6.5 FLOOR FINISHES TO PRINCIPAL ROOMS

Schedule of Changes
2022 Schedule of Changes for 42 Bedford Square - Revision 0

GROUND FLOOR PLAN - PROPOSED

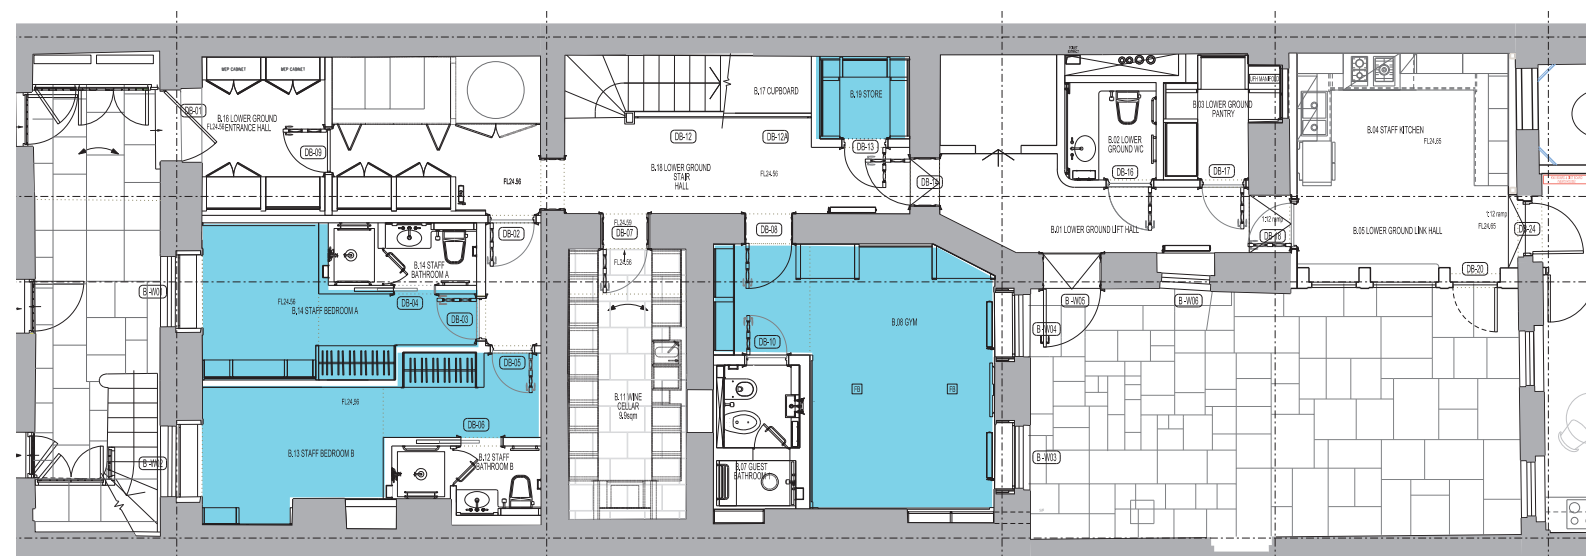
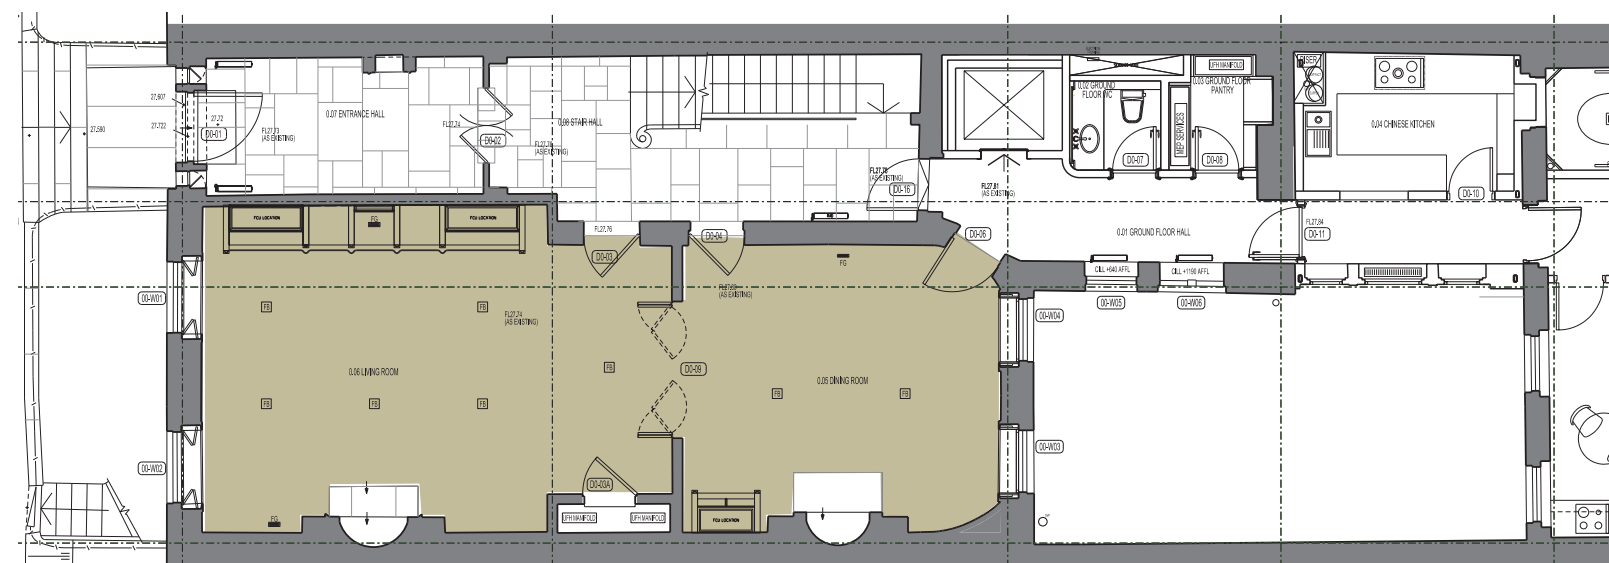
- Parquet floor patterns at Ground Floor and First Floor
- Carpet to Second Floor

Parquet floor patterns are proposed to principal rooms at Ground Floor and First Floor. These were presented as a design development to the consented engineered timber floors in a pre-application workshop of 7th October 2021 with the Conservation Officer and were acceptable.

SECOND FLOOR PLAN - PROPOSED

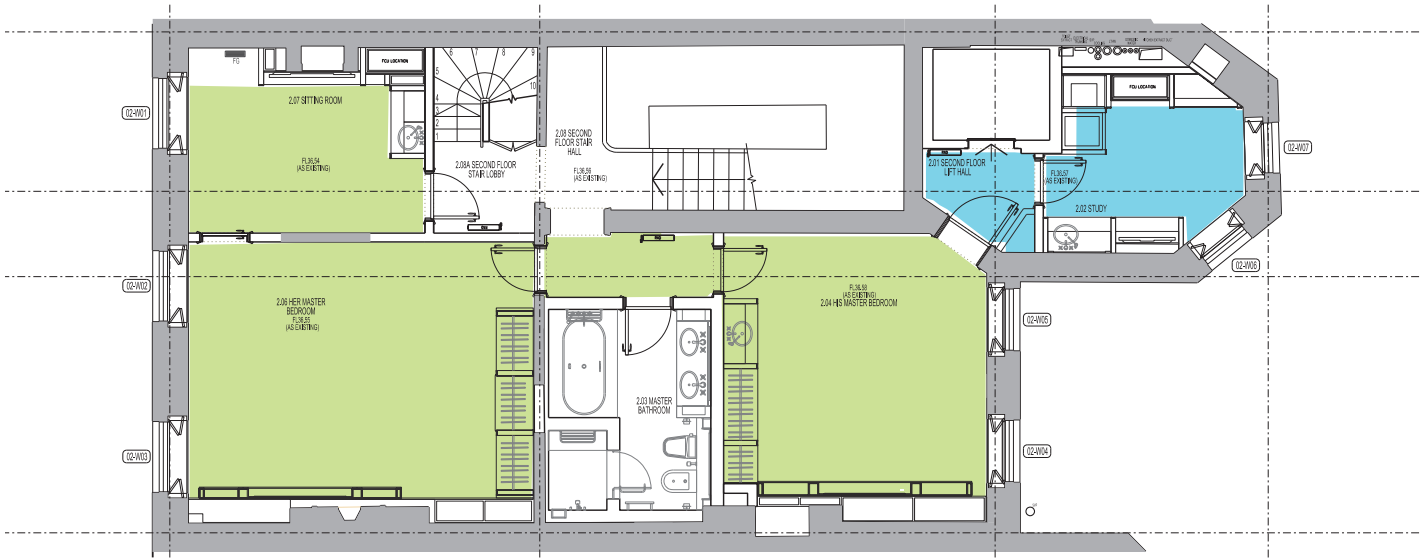
Fitted carpet is proposed in lieu of engineered timber flooring. this is preferred by the end user as a more appropriate floor finish for bedroom areas.

Living Room windows at Ground Floor, with curtains and blinds mock ups

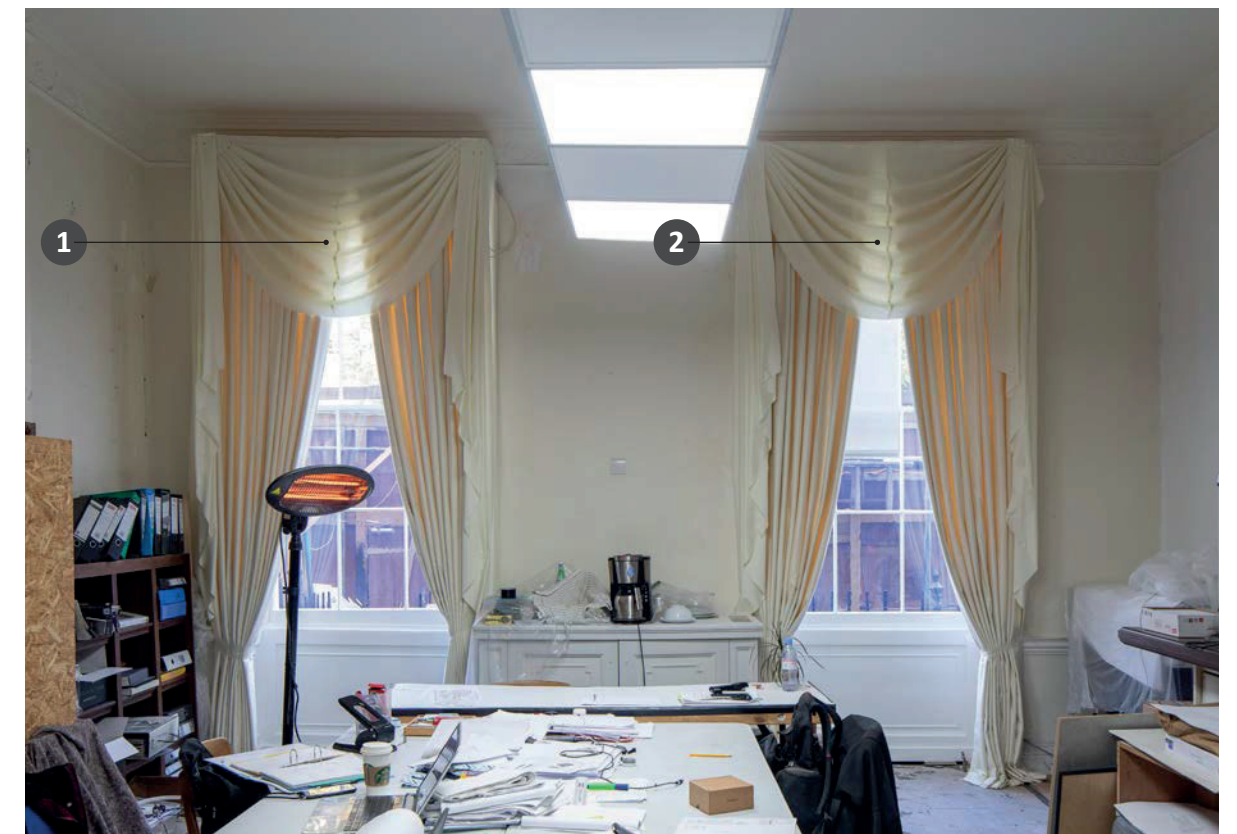
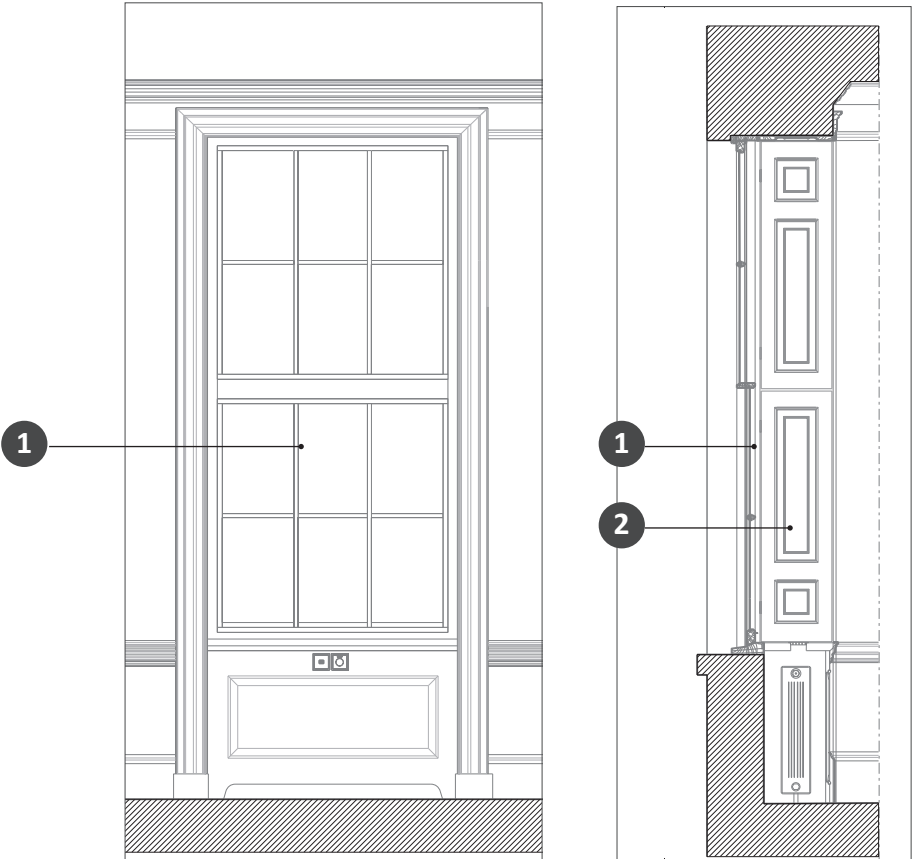
Option 1 featured blinds mounted outside of the window reveal.

Option 2 featured blinds within the window reveal, resulting in a smaller curtain pelmet arrangement. Both options featured dress curtains.

Option 2 has 1 black-out blind within the reveal and a dress curtain & pelmet.

This option has a significantly smaller pelmet projection into the room, requiring less support framing and revealing more of the surrounding decorative plaster work and cornice. These existing features will not be damaged by the pelmet installation and it is therefore considered to be more suitable and easily reversible.

The blind assembly requires a small guide channel with 3no pin fixings to each side. These channels will support the blind box, which is not required to be fixed independently to the existing window joinery.

It is noted that the window shutters will be inoperable while the blinds are in place. However, the proposals are reversible with minimal impact upon the heritage fabric around the windows

The preferred option is Option 2.

Blind and curtain arrangement for Second Floor front windows

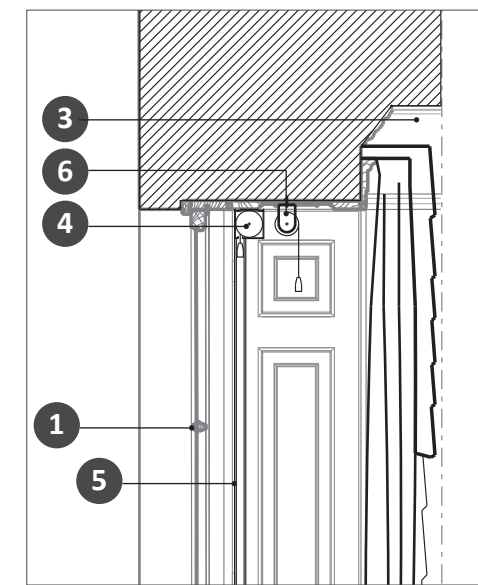
A blackout blind and a sheer blind are proposed to Second Floor windows accompanied by a dress curtain and pelmet. blackout blinds have slim side guides that are reversible. the blind box is simply supported by the side guides. The sheer blind is soffit fixed with removable and reversible fixings.

Lower Ground Floor Entrance Hall

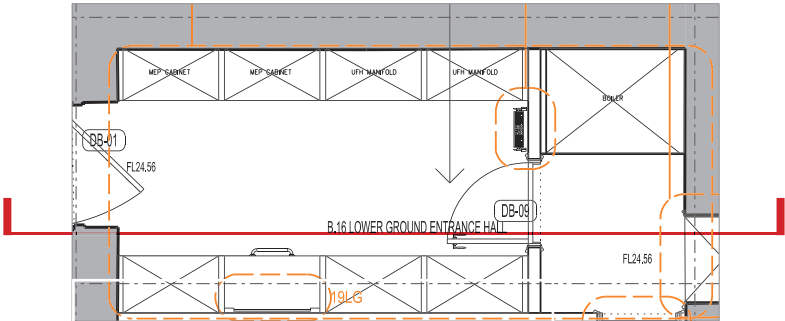
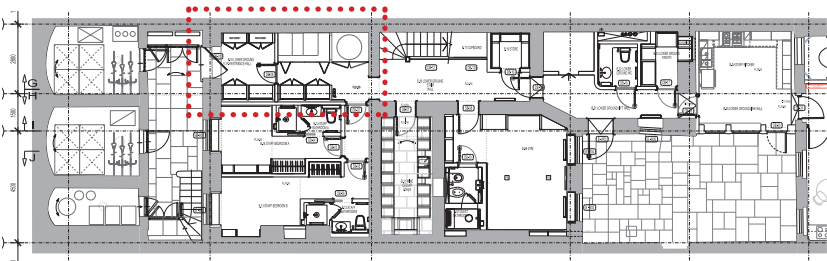
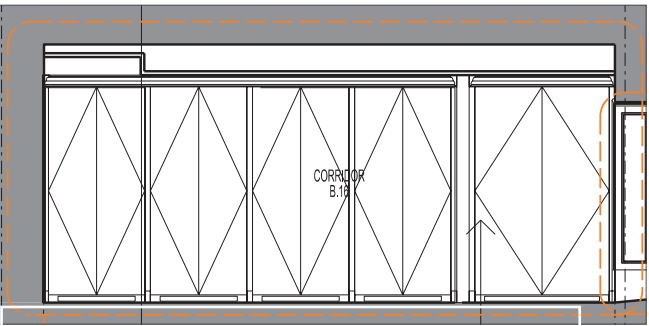
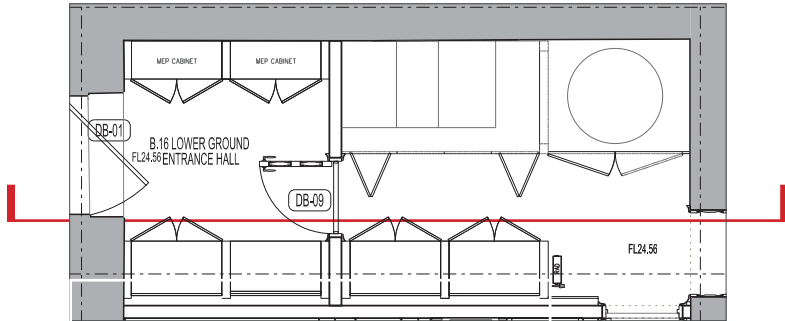
Modifications to the position and layout of fitted cupboards are proposed to suit the revised plan arrangement to accommodate building services. The overall unit heights and character are unchanged. This item was reviewed a pre-application workshop of 16th March 2022 with the Conservation Officer and was acceptable in principle.

Ground Floor Living Room

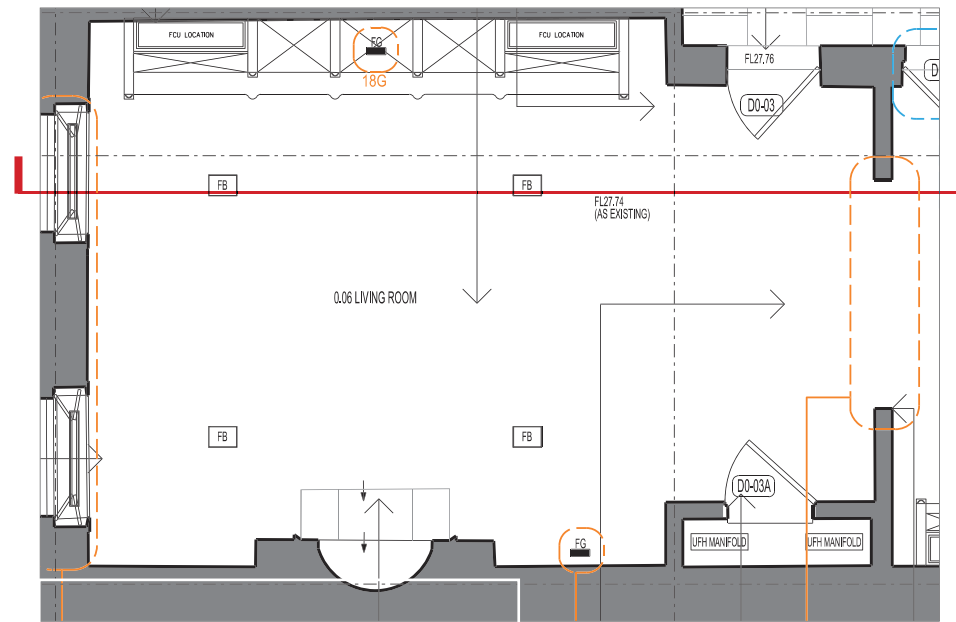
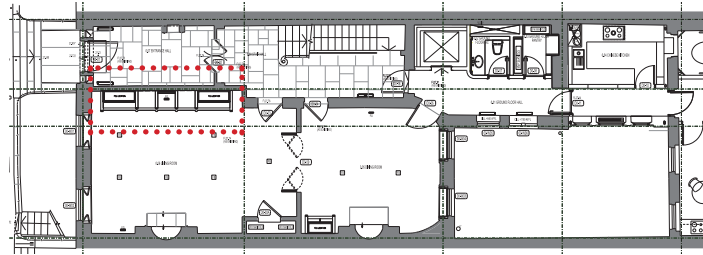
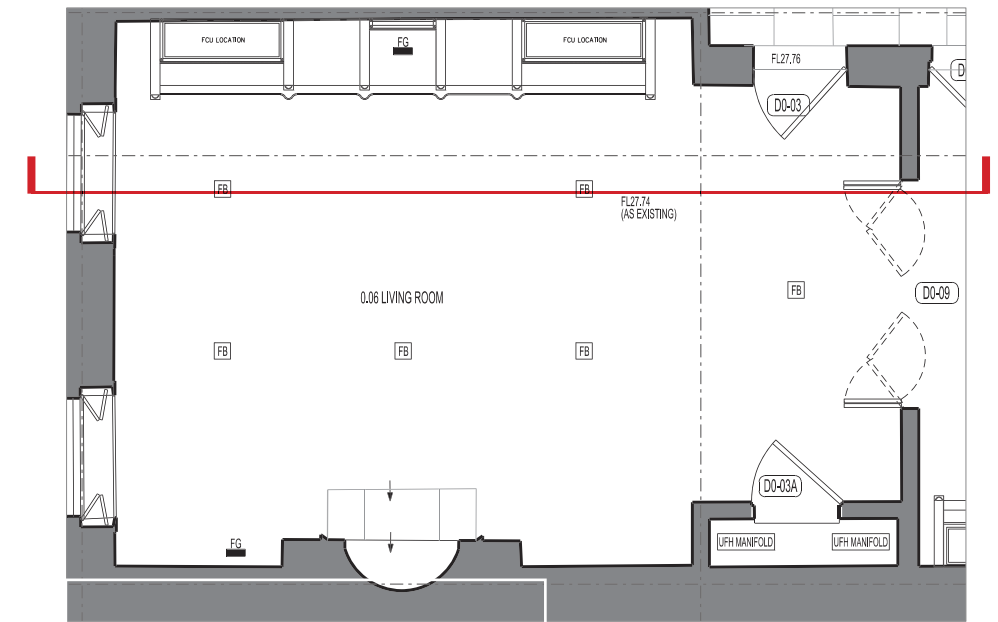
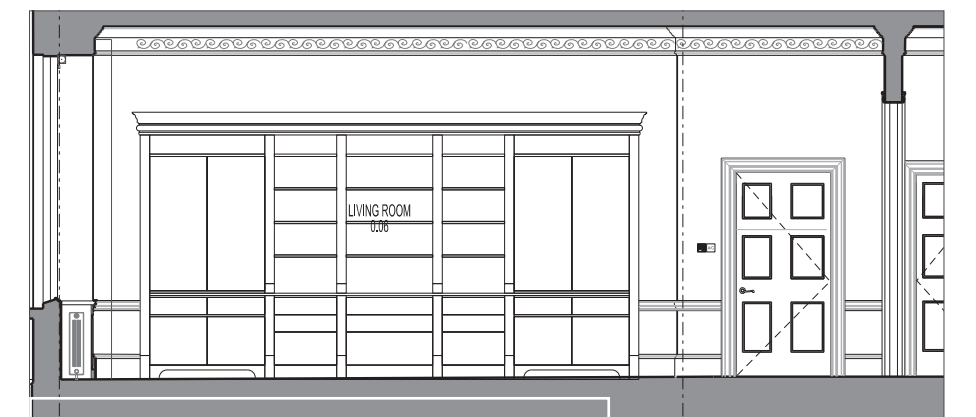
A minor increase in the size and composition of credenza unit to the Ground Floor Living Room is proposed. The change is proposed in order to accommodate and conceal building services.

First Floor Reception

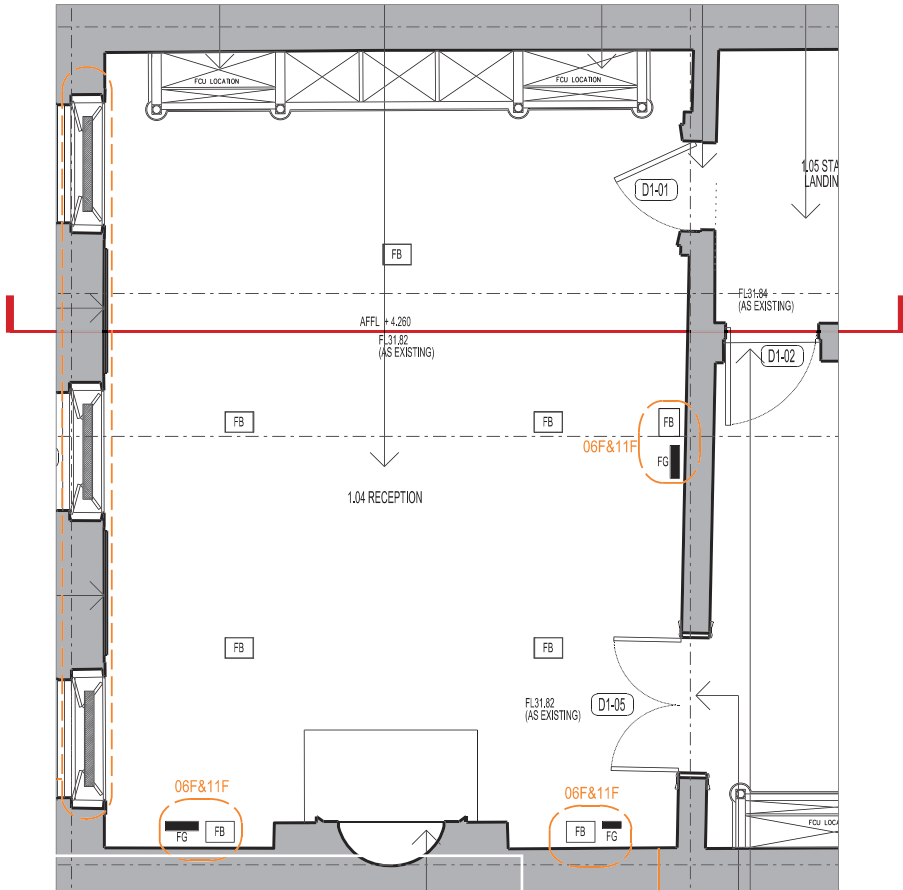
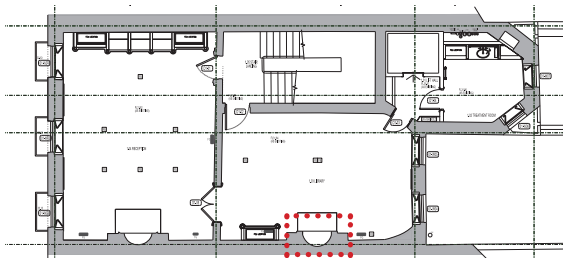
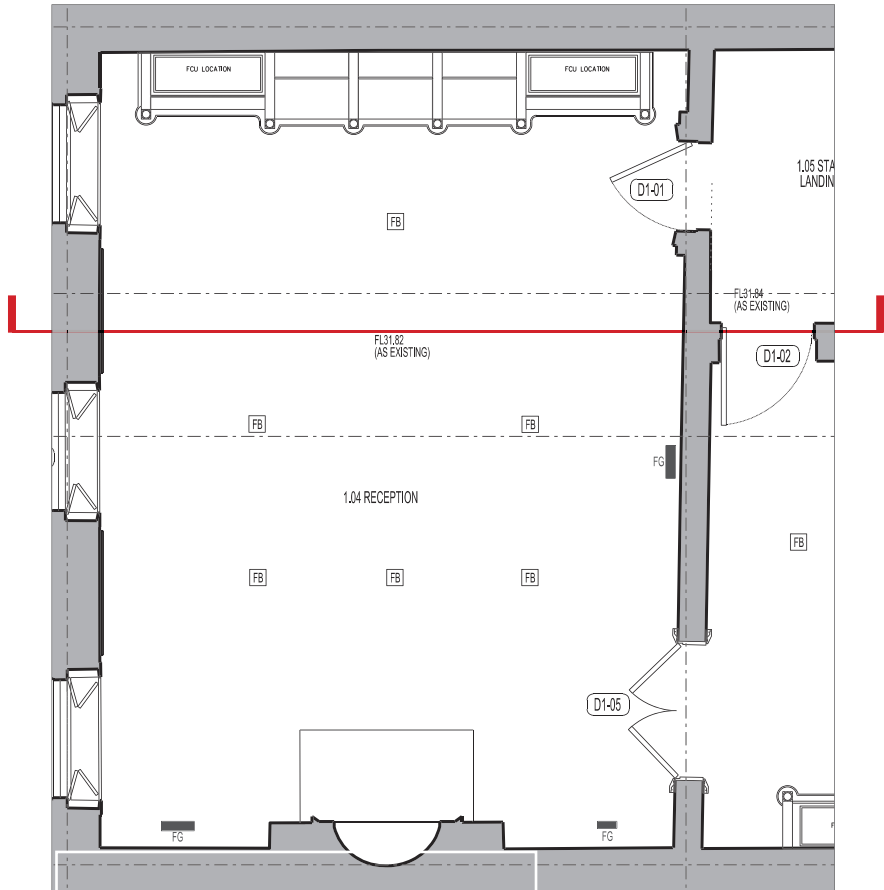
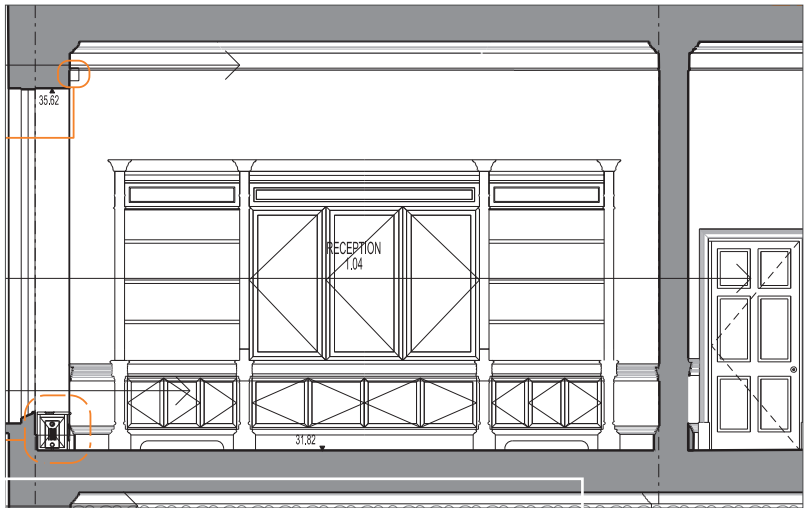
A minor increase in size and composition of credenza unit to the First Floor Reception room is proposed. This change is proposed in order to accommodate or conceal building services. This item was reviewed a pre-application workshop of 13th July 2021 with the Conservation Officer and was acceptable in principle.
